**City of Bellevue
Development Services Department
Land Use Division Staff Report**

Proposal Name: New Bellevue Nissan

Proposal Description: Design Review approval request to convert a former athletic club building and parking garage into a new car dealership and service facility, to demolish one existing retail building to construct a new auto display lot, and to amend an existing Binding Site Plan.

File Number: 13-122633-LD

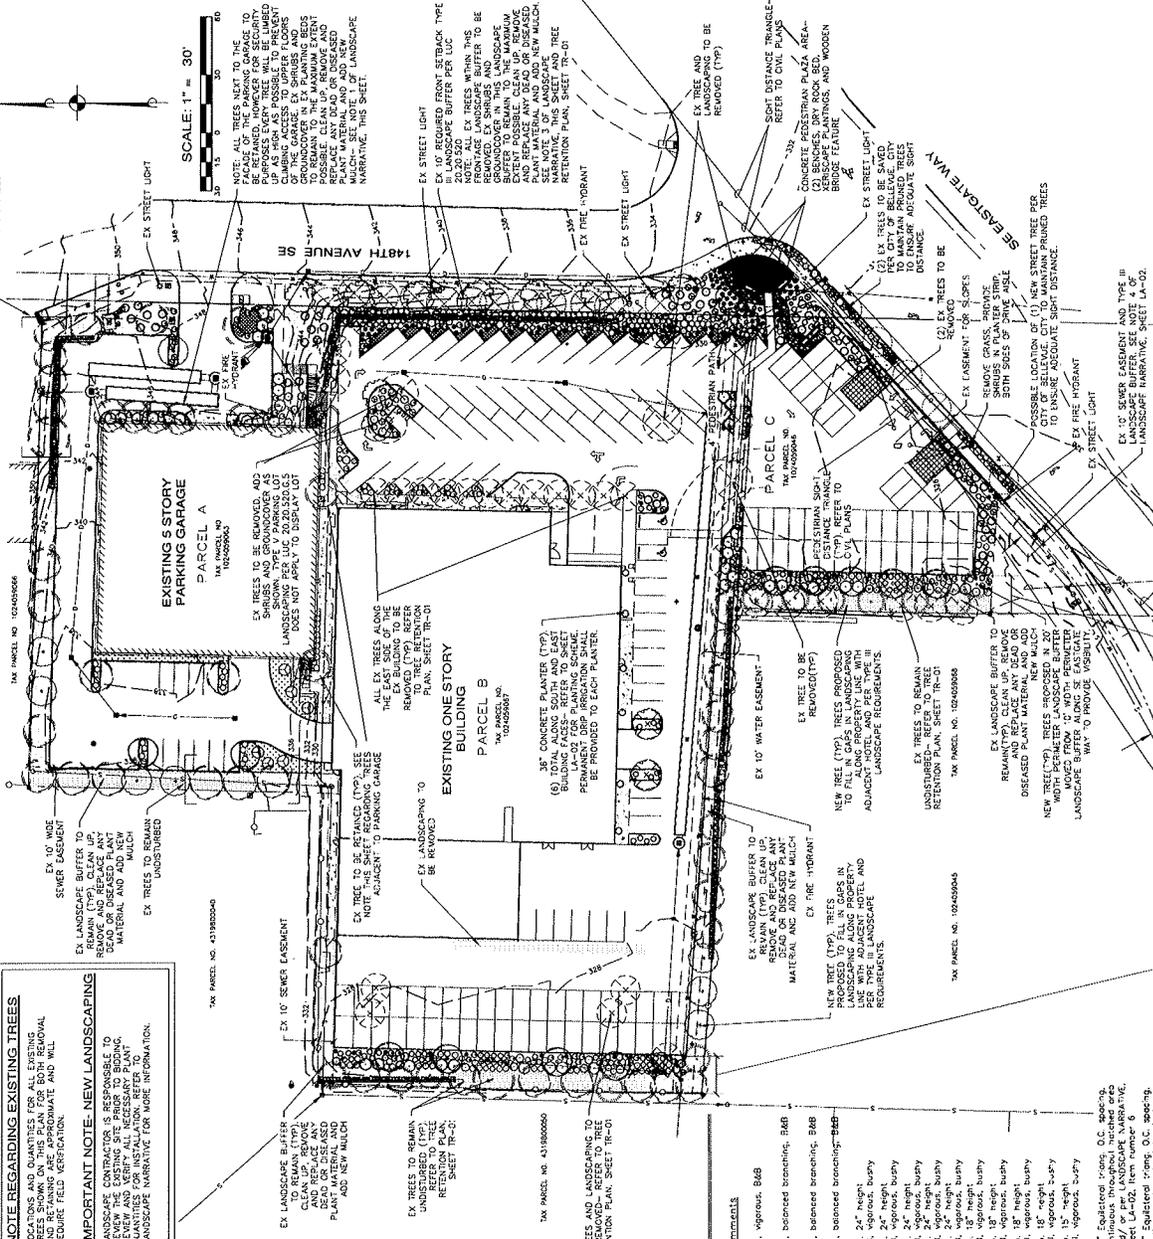
- b) Mountain hemlocks, shown on the submitted plan under Design Review, shall be changed to *Thuja plicata* ‘Hogan’
- c) Replace *Bouteloua gracillis* with a more ornamental, less weedy and invasive grass.

RDG, LLC
 NEW BELLEVUE NISSAN
 TRAFFIC RETENTION PLAN

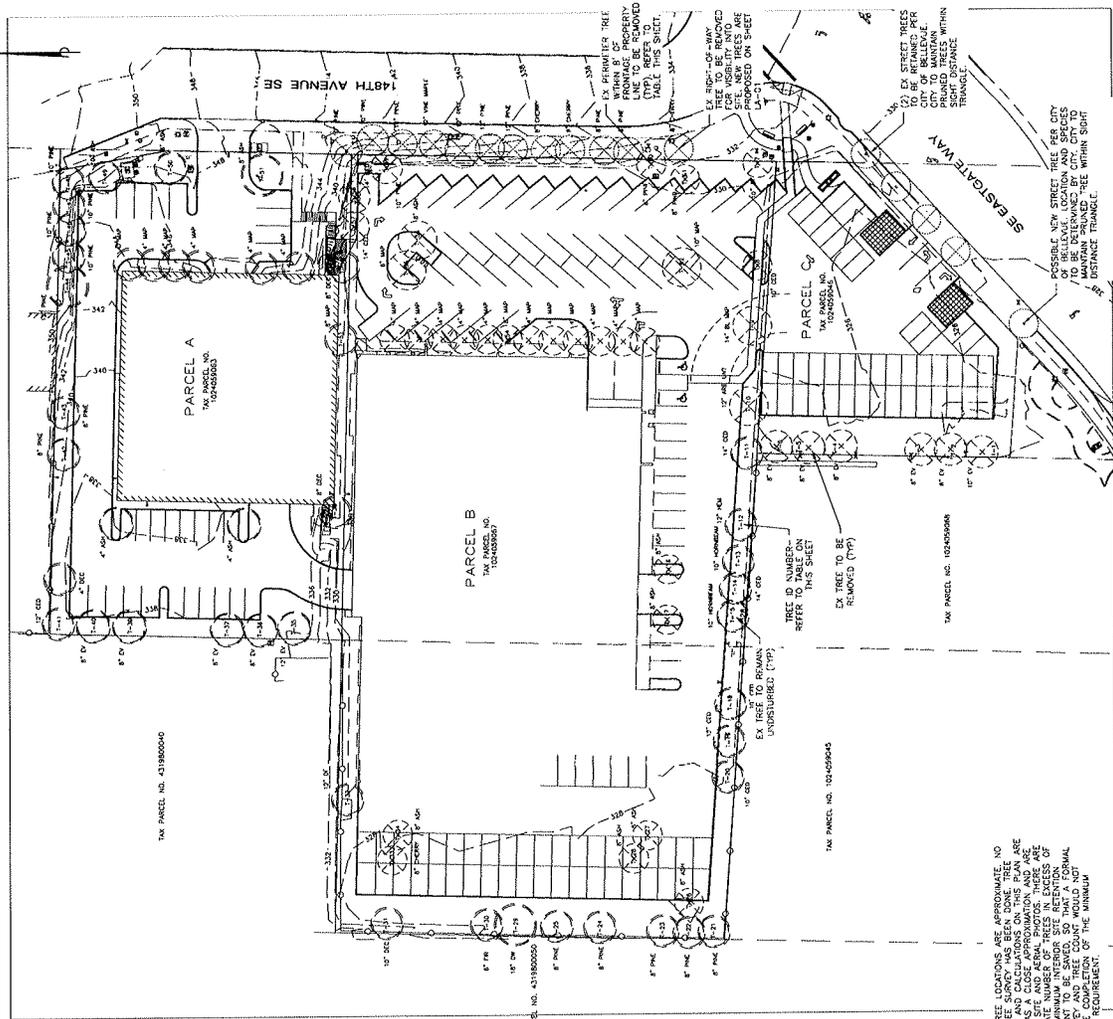
- d) Any evergreen shrub in a required landscape buffer (within the property line) shall be a minimum of 36-42” tall at time of planting.
- e) A revised tree retention plan shall be submitted with the landscape plans to clearly identify street trees, perimeter trees, and interior trees and to provide revised table of diameter inches of trees to be retained and trees to be removed. (For example, trees T-1 through T-6 are to be removed, but on the submitted tree retention plan they are proposed to be retained and T-32 will need to be removed due to conflicts with the garbage enclosure).

- f) To compensate the loss of these additional trees and non-compliance with the perimeter tree retention requirements, the applicant shall plant three (3) additional *Thuja plicata* ‘Hogan’– one to the east and two to the west of the garbage enclosure in the landscape buffer.
